List of Appendices

Appendix 5 – Groundwater advice from Dr Colin Mackie

Request to the Planning Assessment Commission: Russell Vale Colliery Underground Expansion Project

Figure 4: Predicted pre-mining pore pressures on south-north section (E303000)¹⁰

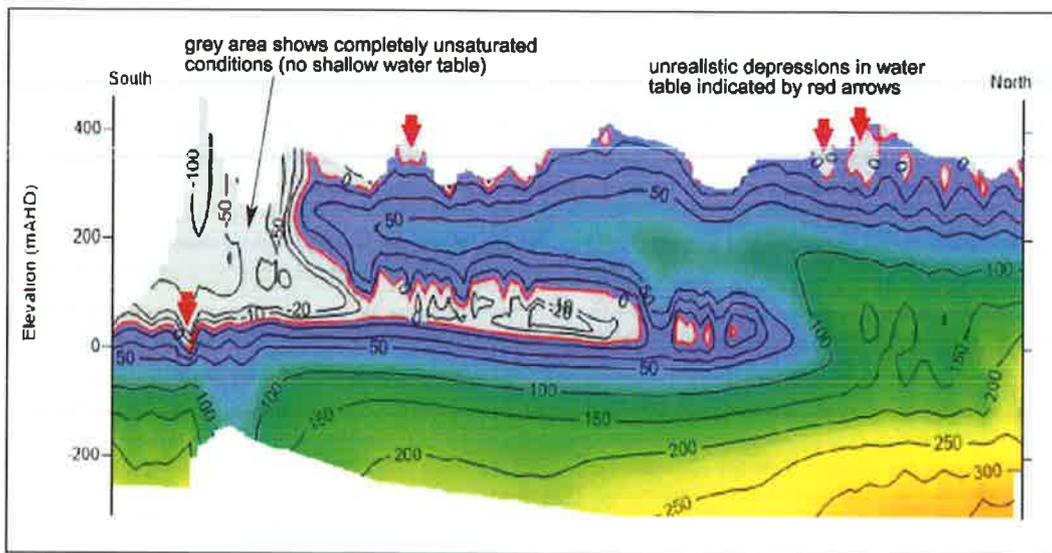
The only representation of the modelled water table in the PPR-RM is on a number of vertical sections that illustrate pore pressure distributions. Figure 4 shows one such vertical section which illustrates the pre-mining pore pressure distributions. Close inspection suggests unusual water table depressions

(or complete loss of the water table) across parts of the model domain casting significant doubt on the usefulness of the reported model.
